SEMMMS A6 to Manchester Airport Relief Road

Aecom: WCML Crossing Option Comparison
(Over v Under)

1007/6.19/108

June 2012

SECTION 2-2
Scale 1:50

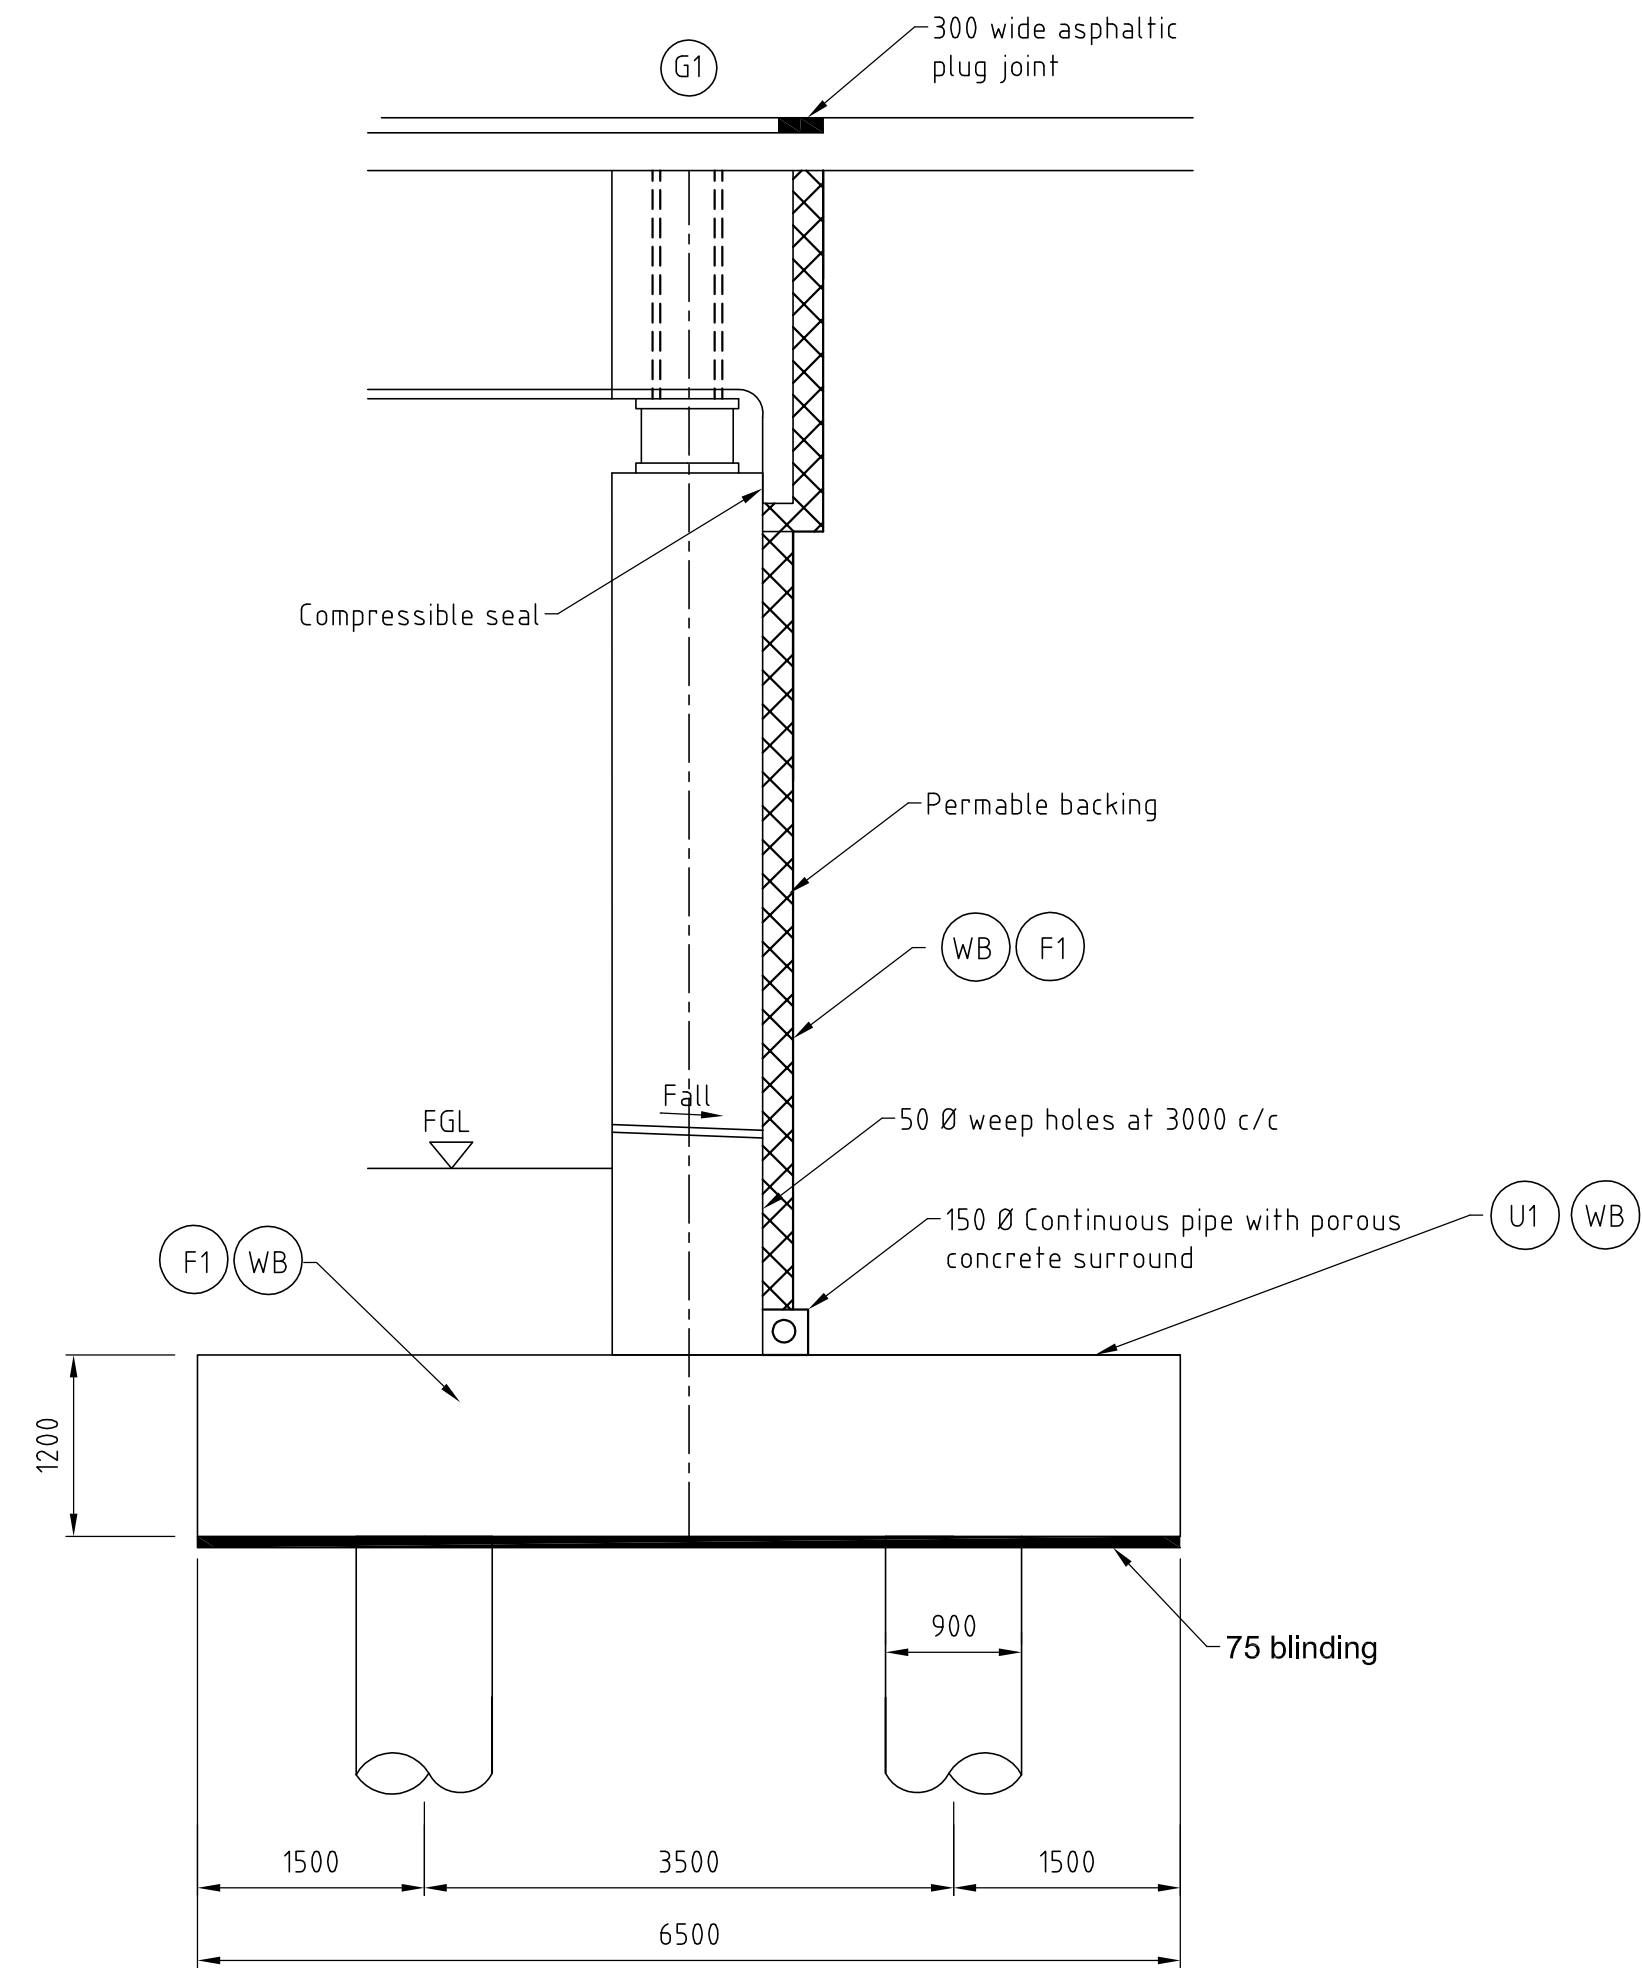
The proposed road over rail bridge as shown on supplied General Arrangement drawing 1007/3D/DF5/A6-MA/B008/708 shows abutments and associated foundations outside of the overall NR rail boundary and therefore all lateral clearances required are satisfied.

A number of possible design options were considered by AECOM in the previous study, and also by Stockport Metropolitan Borough Council. The current proposed design for road over rail structure by Stockport MBC as shown on supplied drawing 1007/3D/DF5/A6-MA/B008/708 is for a composite plate girder made of weathering steel with reinforced concrete slab deck supported on reinforced concrete abutments and piled foundations with splayed wingwalls. The proposed structure is a single span simply supported bridge with semi-integral construction to reduce maintenance problems. The square deck width including the parapet upstands is 25.7m. The skew angle will be approximately 36 degrees.

The single span will be 42.0m measured between abutment faces. This will allow the existing footpath on the west side to remain intact and also allows enough distance on the east side for inspection and possibly replacing the bearings without the need for possession times. This span also allows access for bearing replacements and meets the minimum maintenance requirements for the local authority Stockport MBC. The Council commissioned ND Oliver to carry out a topographic survey at the crossing location and the levels of the OHLEs are known and reflected in the Design Freeze 5 alignment.

It is noted in the supplied preliminary Design Report for this crossing that piles are to be driven. Given the clay ground conditions and proximity of the electrified rail line it is considered that driven piles are not appropriate and that bored piles of similar design will be more appropriate.

The bridge design shown on supplied drawing 1007/3D/DF5/A6-MA/B008/708 is considered appropriate, but consideration should be given to reducing the vertical alignment shown at Design Freeze 5 as there appears to be more clearance over the rail than is necessary.
